ADDENDUM NO. TWO (2)

Date: 2/18/19 Architect's Project No. A18-221

Project: IFB 19-002 Sugar Hill Veterans Memorial Plaza

Client: City of Sugar Hill

Landscaping Plan Revision

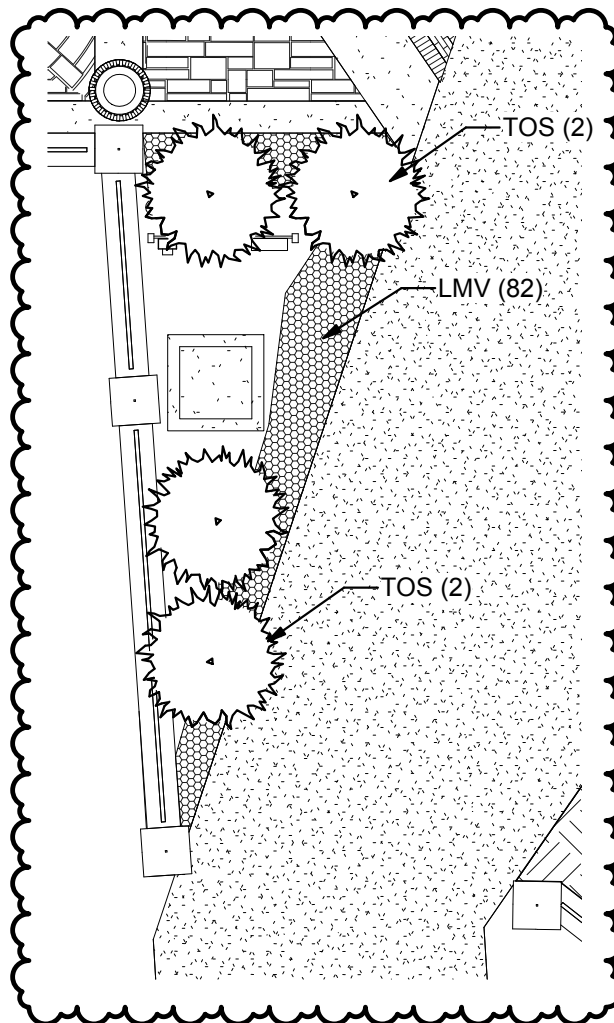
L1.1 Revised landscape bed design at power transformer. Refer to attached Exhibit A01.

Reference Plan Revision

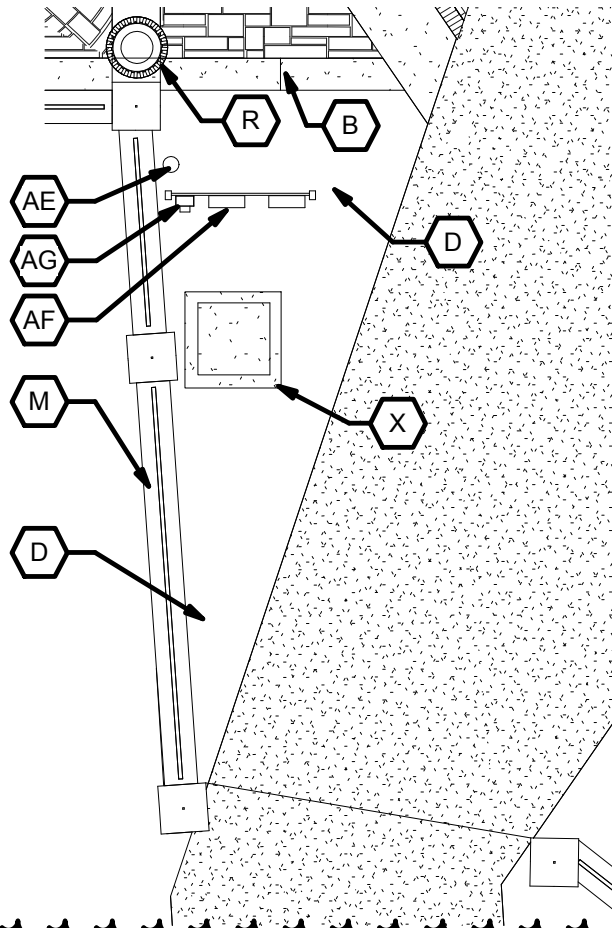
A1.2 Revise Plaza Plan Keynotes as indicated below. Refer to attached Exhibit A02.

- 1.) Keynotes "AC, AD, AE, AF, and AG" have been added to New Plaza Plan 1/A1.2.
- 2.) Keynote "AB" has been revised to read: "NEW CONCRETE RIGID PAVEMENT DRIVEWAY CONSISTING OF 6" #57 STONE BASE AND 6" THICK 3,000 PSI CONCRETE PAVING WITH EXPANSION JOINTS AT 50' O.C. MAX AND CONTROL JOINTS AT 15' O.C. MAX."

- AB NEW CONCRETE RIGID PAVEMENT DRIVEWAY - REFER TO SPECIFICATIONS
- AC NEW BRICK PAVER STRIPE TO MATCH CITY STREETSCAPE STANDARD - REFER TO BRICK PAVER STRIPE DETAIL THIS SHEET
- AD NEW BRICK PAVER SIDEWALK AREA TO MATCH CITY STREETSCAPE STANDARDS - REFER TO BRICK PAVER PLAN DETAIL THIS SHEET
- AE VAULT VENT - REFER TO FOUNTAIN DRAWINGS
- AF PANEL BOARD - REFER TO A1.5
- AG ELECTRICAL METER - REFER TO ELECTRICAL

Electrical Panel Backboard

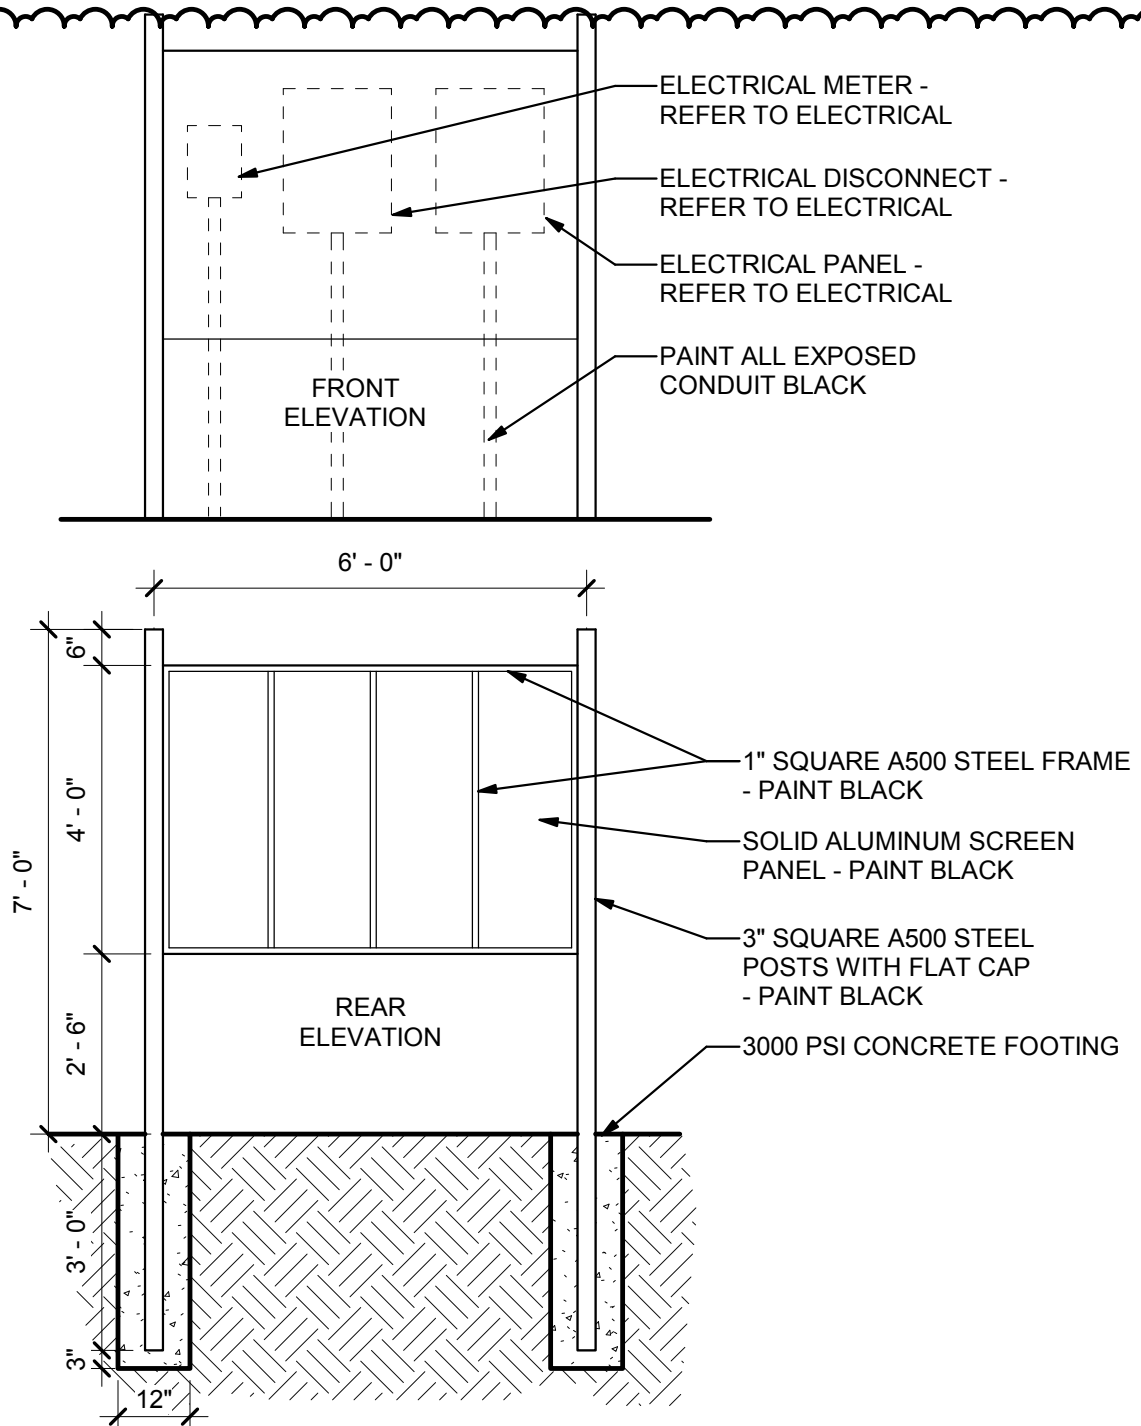
A1.5 Added detail 6/A1.5 Panel Backboard Detail to sheet A1.5. Refer to attached Exhibit A03.

FOUNDATION
PLAN

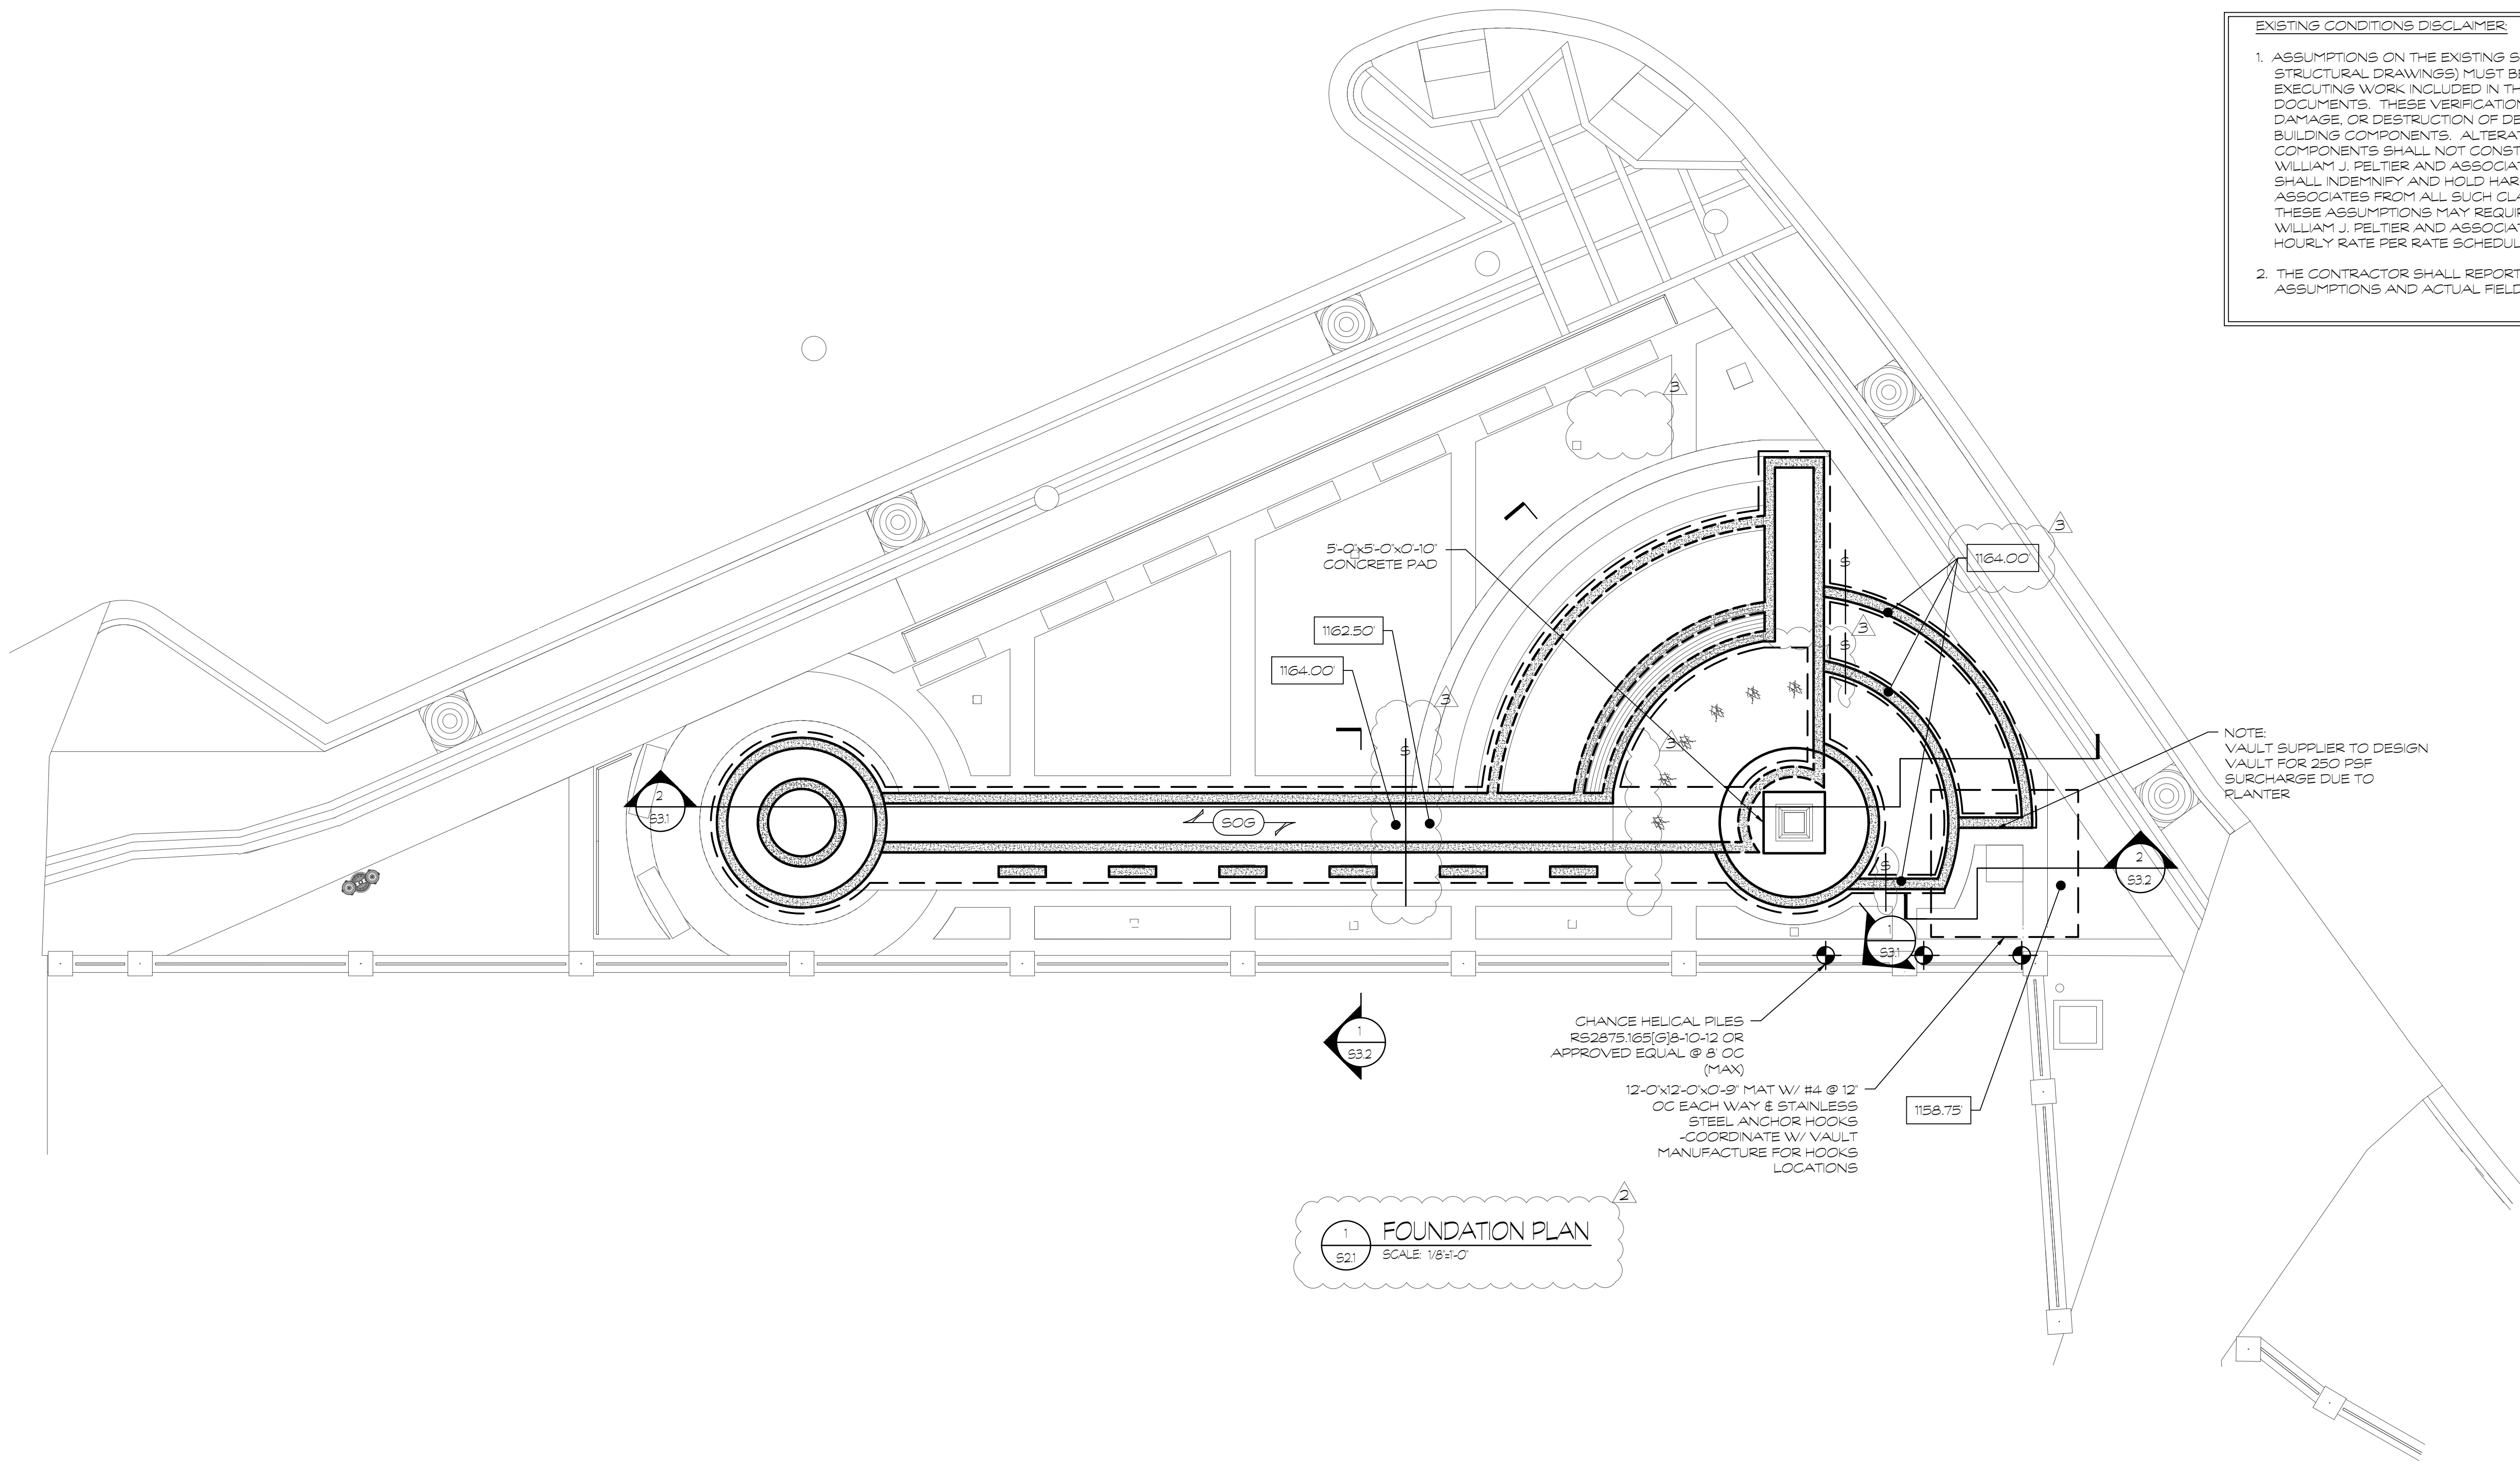
S2.1 Revised top of footing at center section of the monument to 1162'-6" to minimize number of steps in footing. Refer to attached sheet S2.1.
